Work Order ID 164246

Item Name: Lug

DRAWING NO. D3394	TITLE LUG	REV. B	DART AEROSPACE LTD ENGINEERING ORDER		D.E.O. NO. D3394-B-1	SHEET NO. SHEET 1 OF 1	SCALE NTS
DRAWN AJS	CHECKED		MFG. APPR.	APPROVED		DE APPR.	
DATE 09.11.04	DATE 09.11.04		DATE 09.11.04	DATE 09.11.04		DATE 09.11.04

DRAWING NO.	D3394	REV. B	DART AEROSPACE USA, INC	D.E.O. NO.	D3394-B-2	SHEET NO.	SHEET 1 OF 1	SCALE	NTS
DRAWN	q	CHECKED	SC	MFG. APPR.	M	APPROVED	M	DE APPR.	W
DATE	11.05.02	DATE	11.05.07	DATE	11.05.08	DATE	11.05.08	DATE	11.05.09

D3394-1RG LUG (SHOWN)
D3394-3RG/-5RG LUGS (SIMILAR)
D3394-041RG/-043RG/-045RG LUG ASSEMBLIES (SIMILAR)

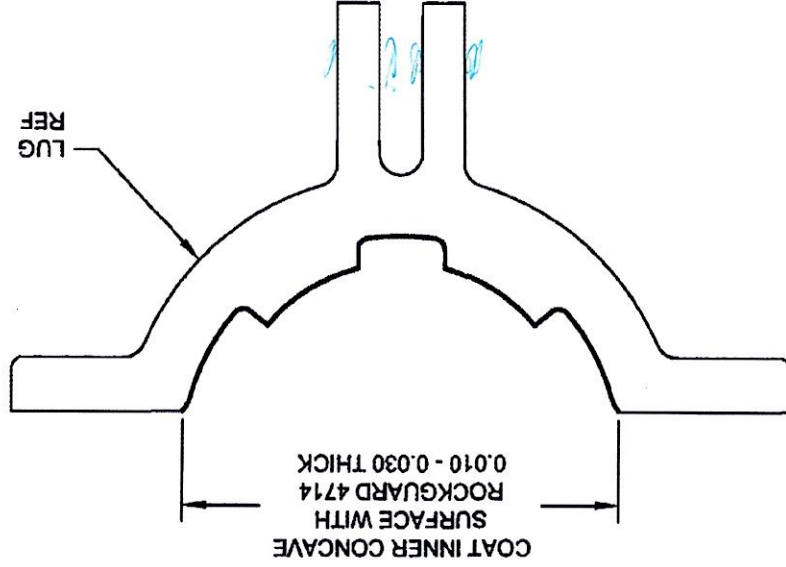
PURPOSE
ADD D3394-xRG OPTION

CHANGE
D3394-xRG MOUNTING LUGS ARE IDENTICAL TO D3394-x MOUNTING LUGS, HOWEVER AFTER FINISH, COAT INNER CONCAVE SURFACE WITH "PLUS ONE ROCKGUARD 4714" AS SHOWN BELOW.
